Docket Number:	00-AFC-01C
Project Title:	Contra Costa Power Plant Project Compliance
TN #:	202372
Document Title:	Petition for Insignificant Proj Change_Additional Steam Turbine Decking
Description:	N/A
Filer:	Angel B. Espiritu
Organization:	PG&E Gateway Generating Station
Submitter Role:	Public Agency
Submission Date:	5/23/2014 9:42:43 AM
Docketed Date:	5/23/2014

Subject: PETITION FOR INSIGNIFICANT PROJECT CHANGE TO PLANT FACILITY

**PETITION FOR INSIGNIFICANT PROJECT CHANGE
AT
GATEWAY GENERATING STATION (GGS)**

1. Installation of Additional Decking on North Side of Steam Turbine Deck:

FIGURE 1

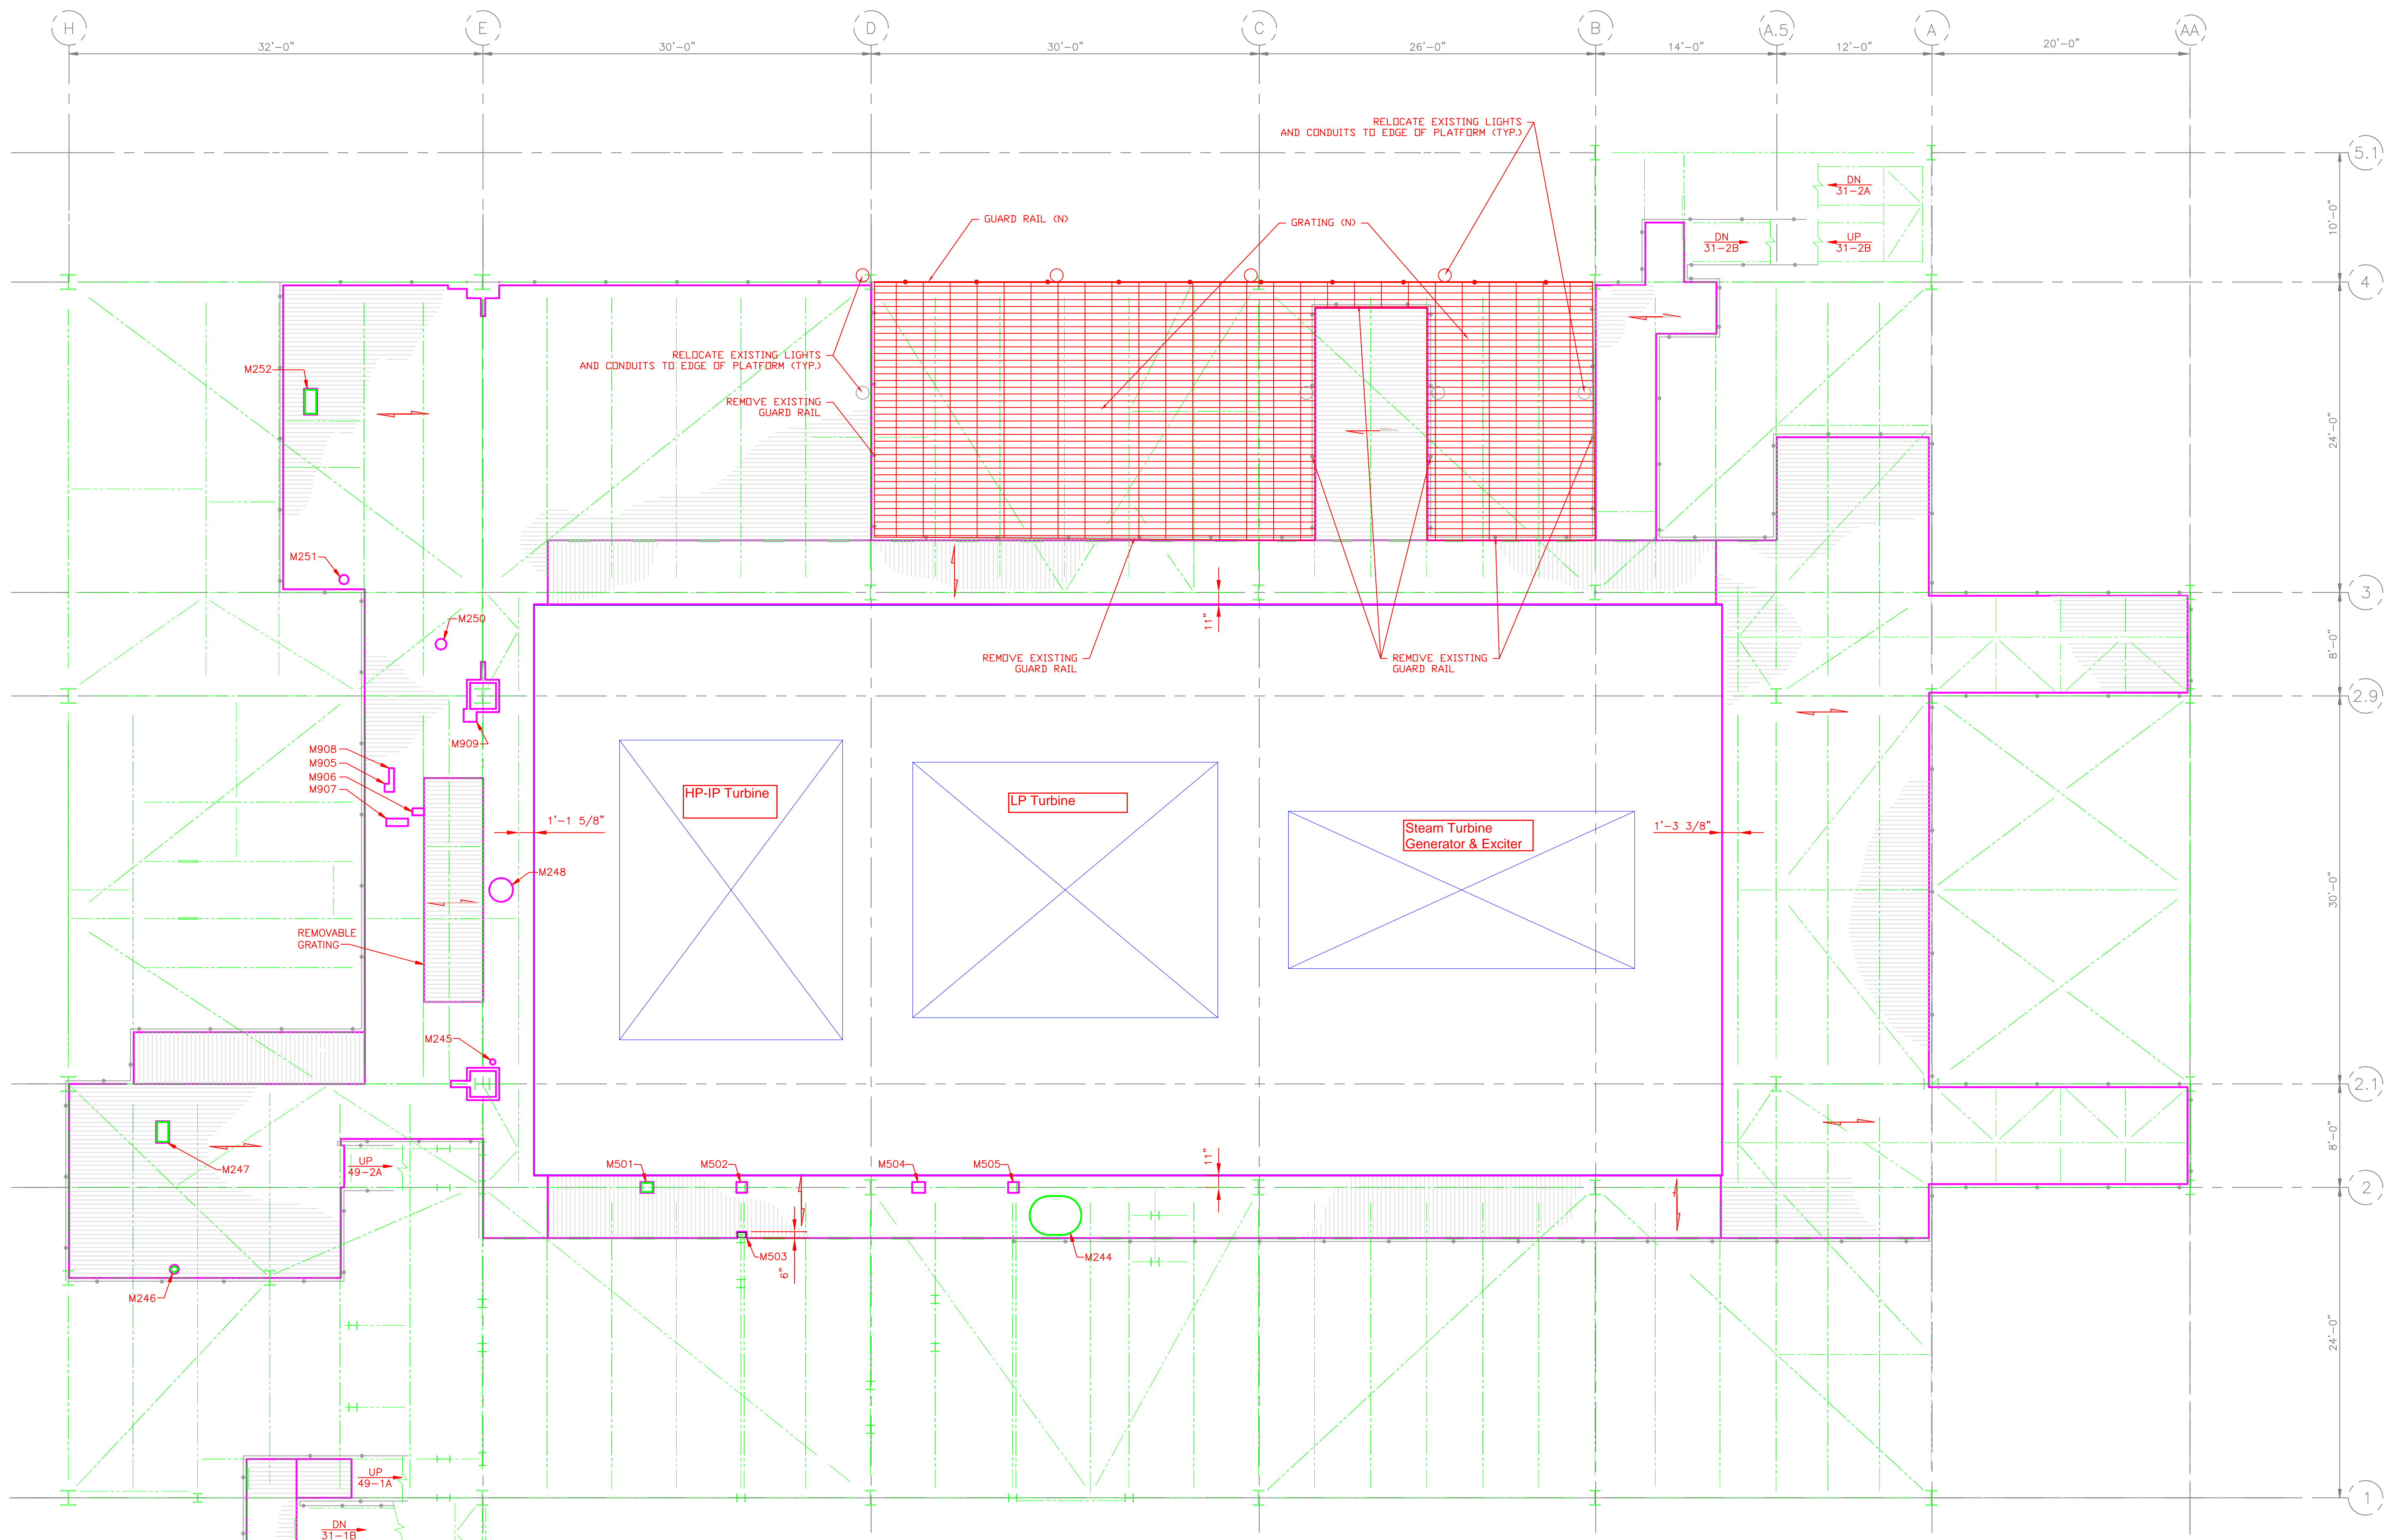
The current GGS steam turbine deck configuration has 2 open areas on its north side which were not originally fitted with grating-type decking during plant construction -- see proposed grating addition areas marked in red in upper half of Figure 1 (see attached drawing).

- a. Description of Modification: PG&E proposes to: 1) Relocate the area lighting and associated electrical power supply conduit runs currently located along the perimeter of the cited open Steam Turbine Deck areas; 2) Install grating in the areas marked in red as depicted in Figure 1.

SHEET TITLE: NEW STEAM TURBINE DECK
DEMO / CONSTRUCTION PLAN
OWNER: PACIFIC GAS & ELECTRIC COMPANY
GATEWAY GENERATING STATION
ANTIOCH, CA. 94509

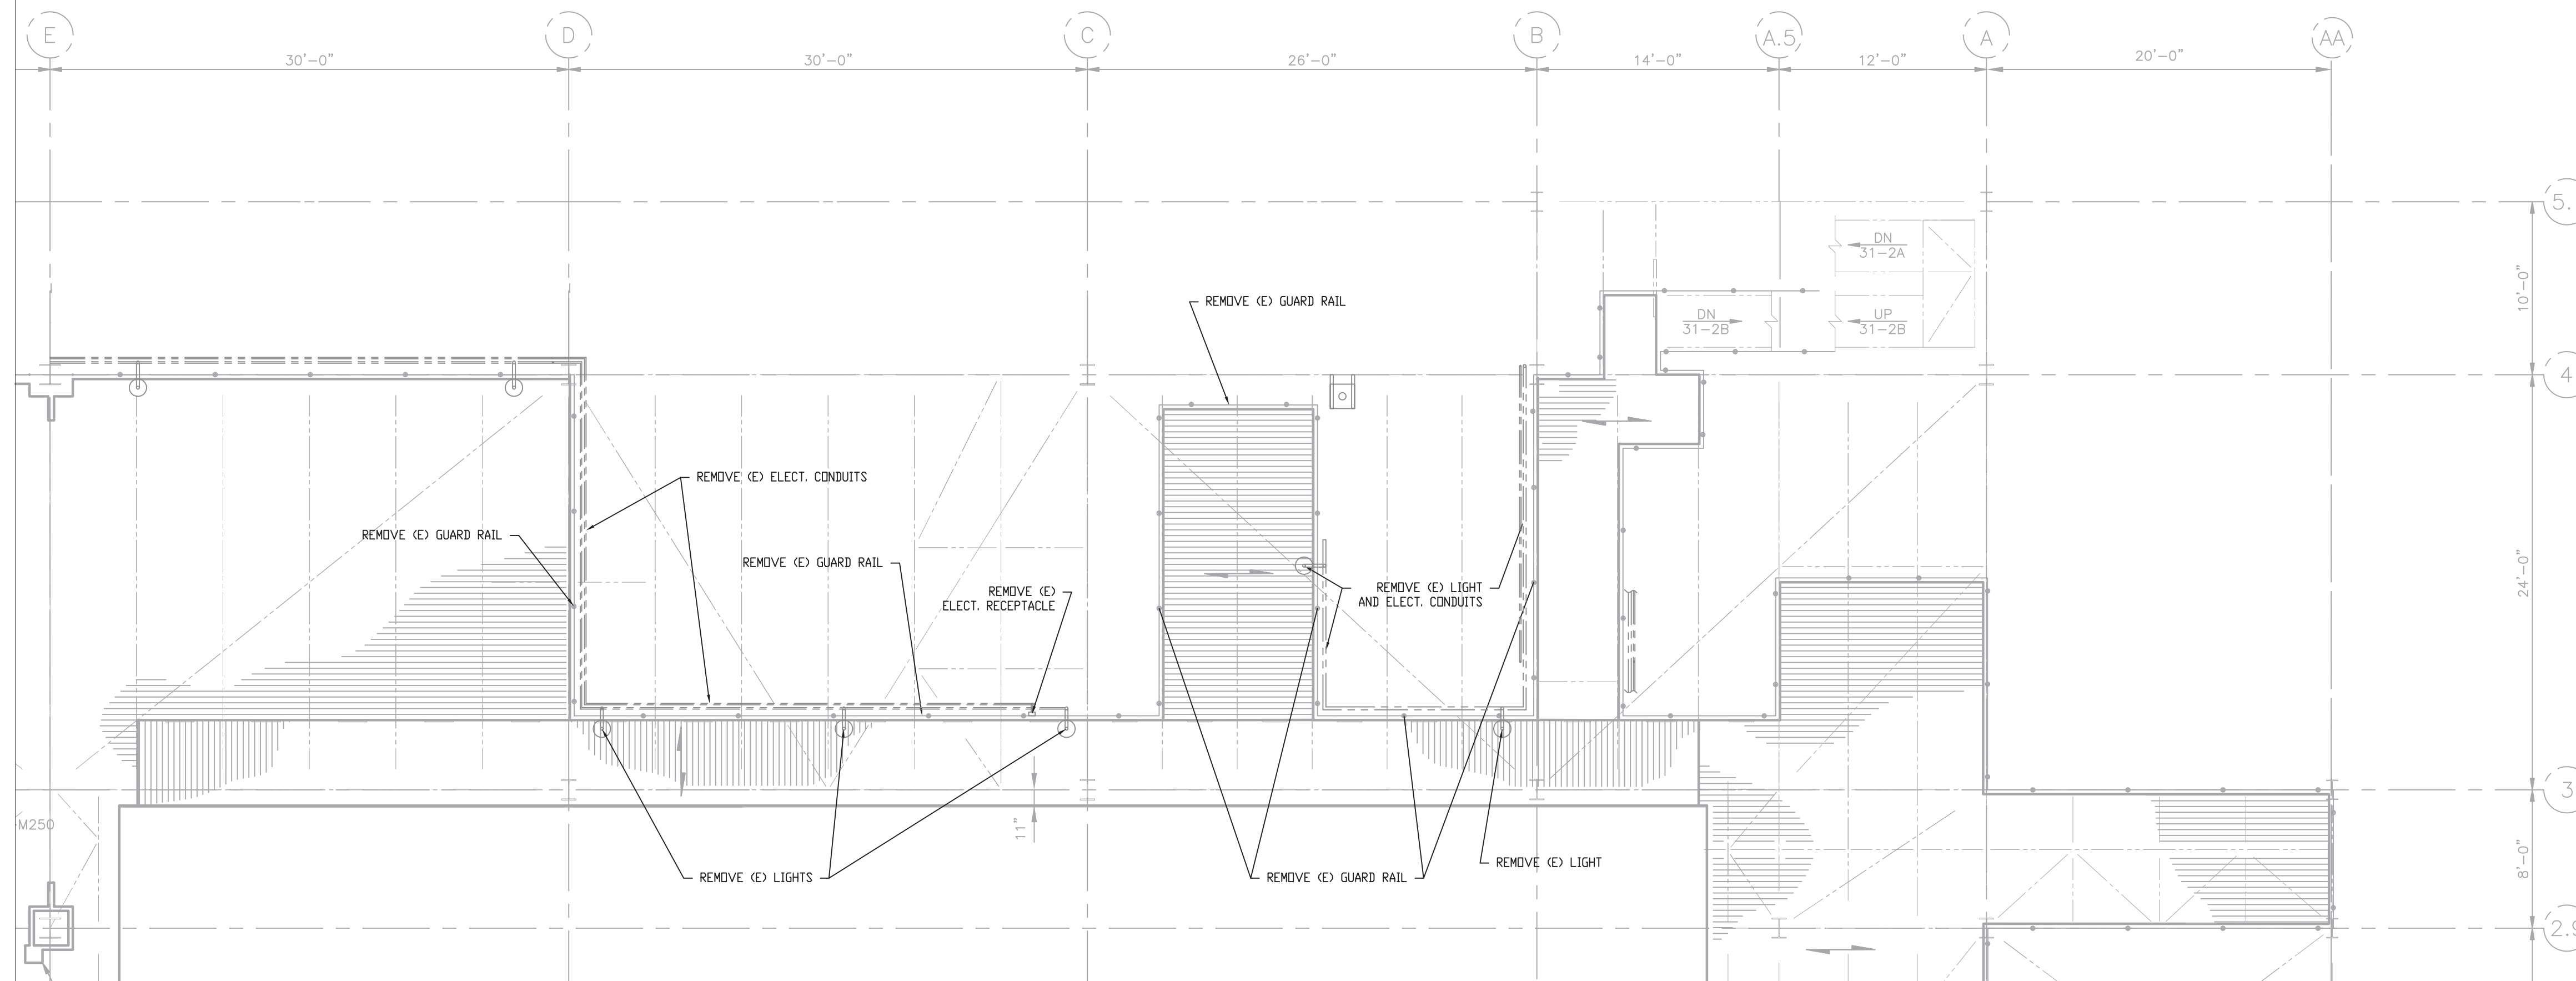
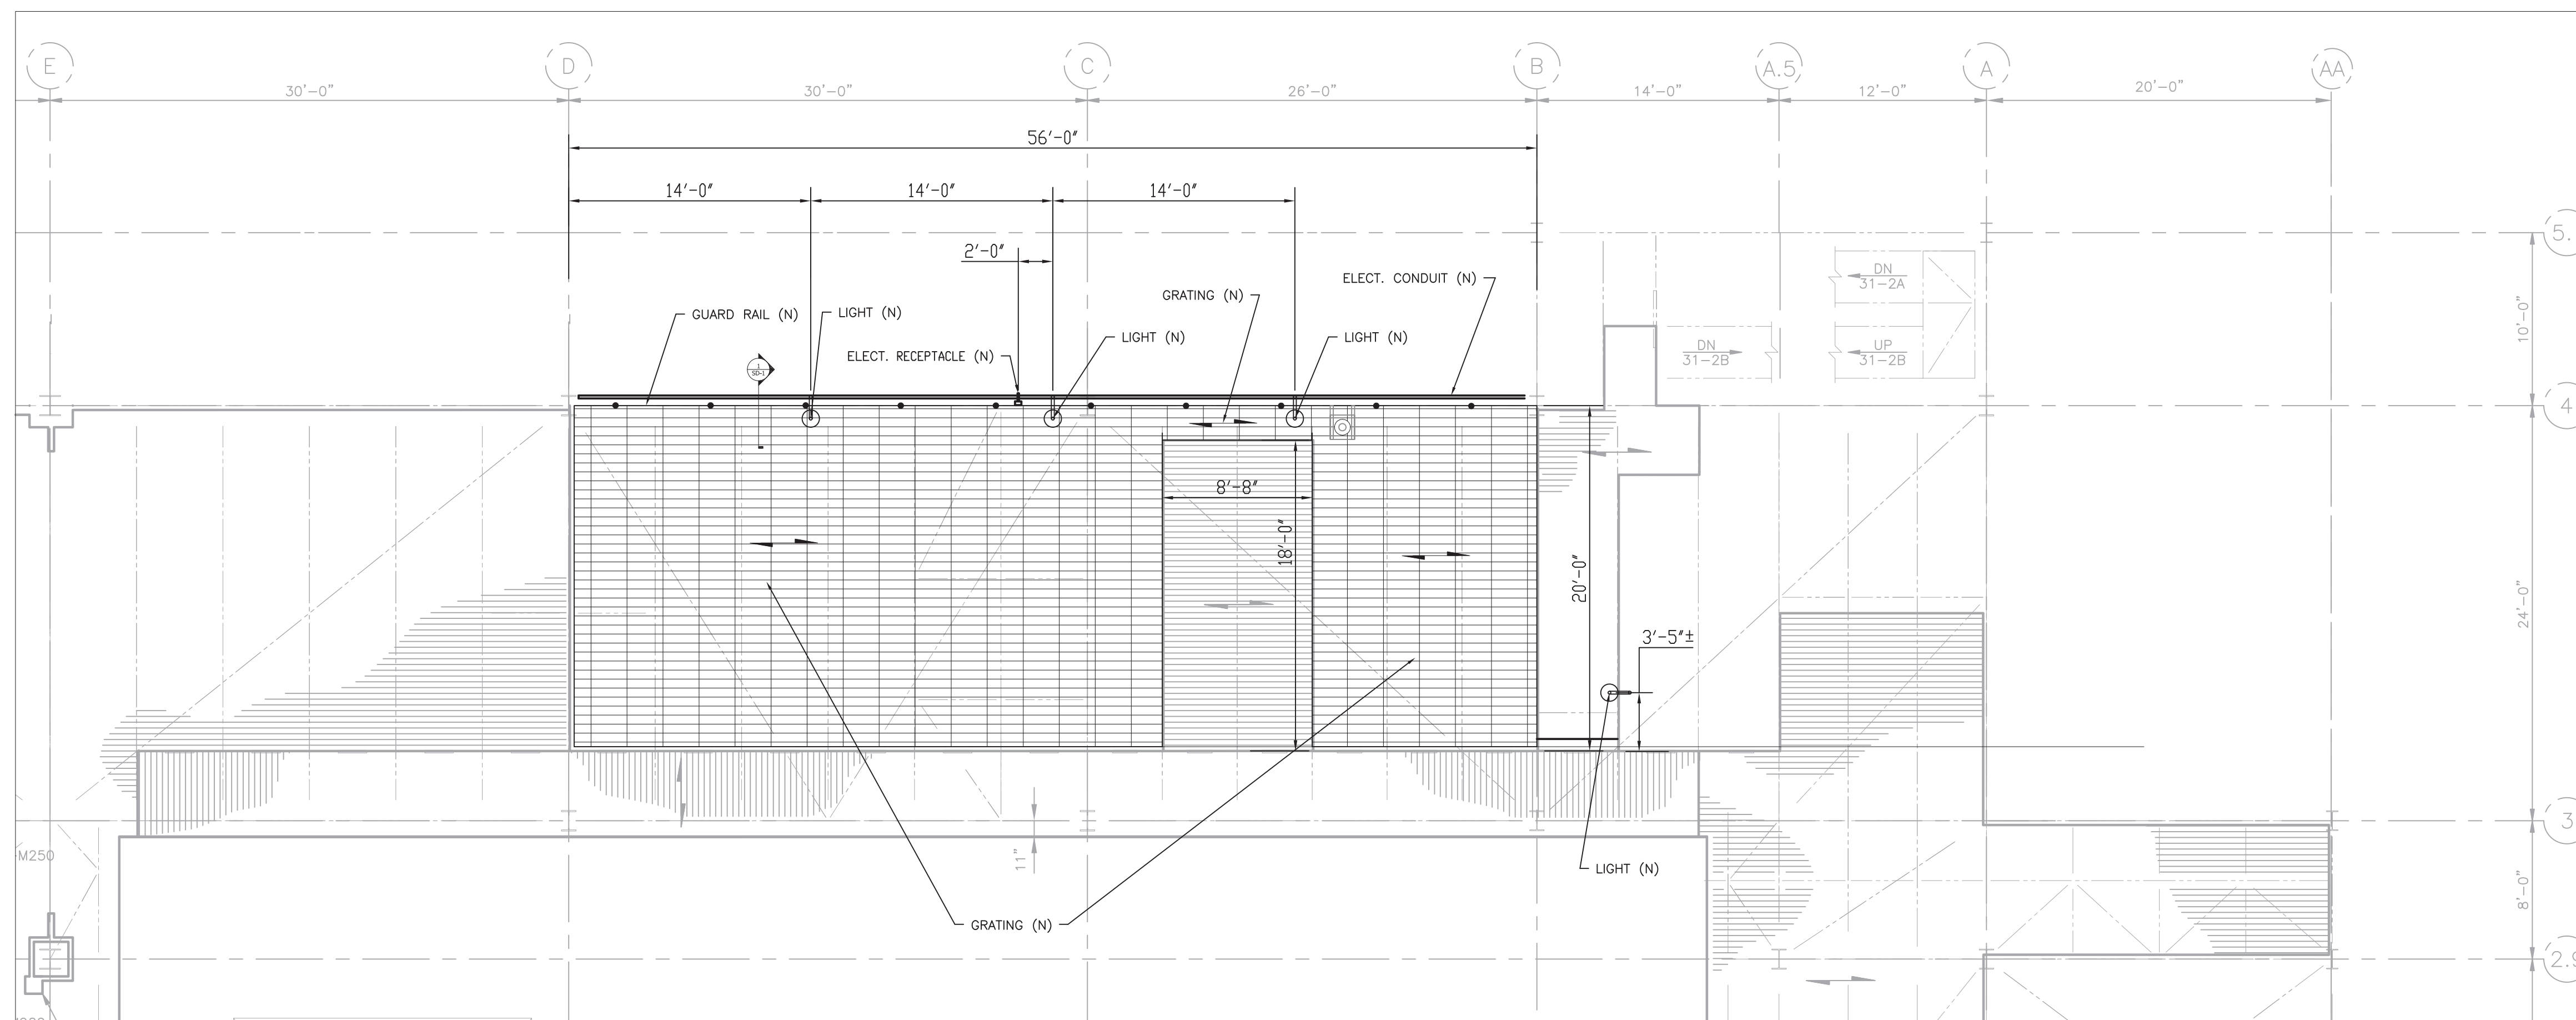
1. EXISTING EQUIPMENT AND PIPING IS PARTIALLY SHOWN ON PLANS. CONTRACTOR TO VERIFY ALL DIMENSIONS, ALIGNMENTS, AND CLEARANCES.
2. DISCREPANCIES: SEE GENERAL NOTES, #9, SHEET S-1.
3. GRATING TO BE W-19-4 WITH 1 1/2" X 3/16" SERRATED STEEL BARS.
4. CONTRACTOR TO REUSE/RELOCATE EXISTING LIGHTS, CONDUITS, GUARD RAILS, AND ETC..
5. SEE SHEET SD-1 FOR TYPICAL RAILING DETAILS.
